SUBJECT: MAKEUP TO MITIGATE LARGE LOCAS OUTSIDE OF  
CONTAINMENT AT SHOREHAM

## ENCLOSURE A

### MAKEUP FROM CONTROL ROD DRIVE HYDRAULIC SYSTEM AND

### CONDENSATE PUMPS FOLLOWING LOCA OUTSIDE OF PRIMARY CONTAINMENT

Figure 1 Break Paths

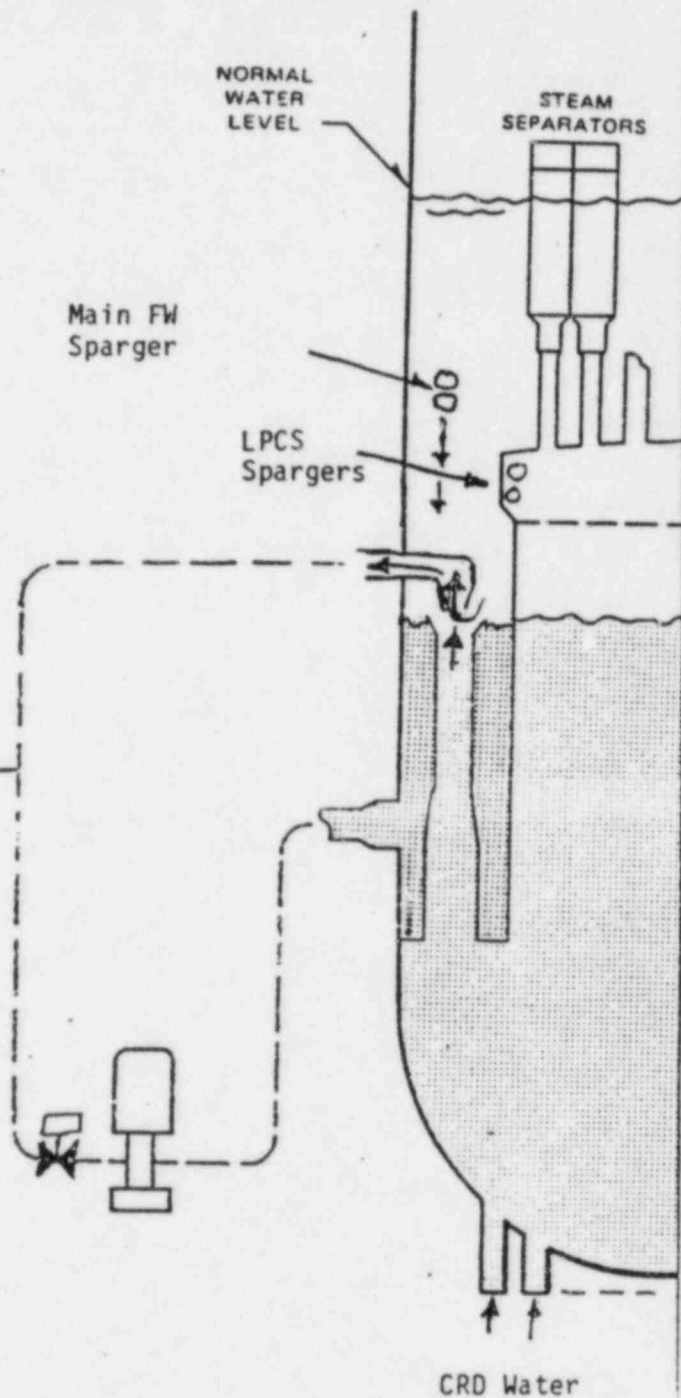
The 20" RHR letdown line connects to the 28" suction leg of recirculation loop B. This line has inboard and outboard isolation valves (gate valves F008 and F009) which have interlocks to prevent opening or to close the valves if the RCS pressure exceeds a setpoint. Failure of these valves and a resulting break in the low pressure portion of the RHR system could result in a large break in the Reactor Building. Following closure of the recirculation pump discharge valves, the leakage path from the RPV, as shown in Figure 1, is the recirculation pump suction line of loop B which connects to the vessel near the bottom of the downcomer. This leakage path would result in the loss of essentially all of the 1000 gpm from the condensate pumps which enters the pressure vessel at the main feedwater sparger. Note that the postulated flow of subcooled condensate water is sufficient to condense the steam generated by decay heat within a short time after blowdown. However, the condensed steam and the condensate supply are lost through the break.

A break in the RWCU line involves considerations similar to those discussed for the break in the RHR letdown line since the connection is to the suction leg of the recirculation loop and the vessel leakage path after closure of the pump discharge valve is the same. A 6" break ( 0.2 ft. 2) is relatively small. However, we assume loss of HPCI and RCIC and depressurization via ADS to a vessel pressure of about 50 psia, the lowest pressure at which the SRVs at Shoreham can be kept open. This break would result in the loss of all of the 1000 gpm from the condensate pumps. When subcooled condensate water gets to the vessel, it would be heated to the saturation temperature during the fall from the feedwater
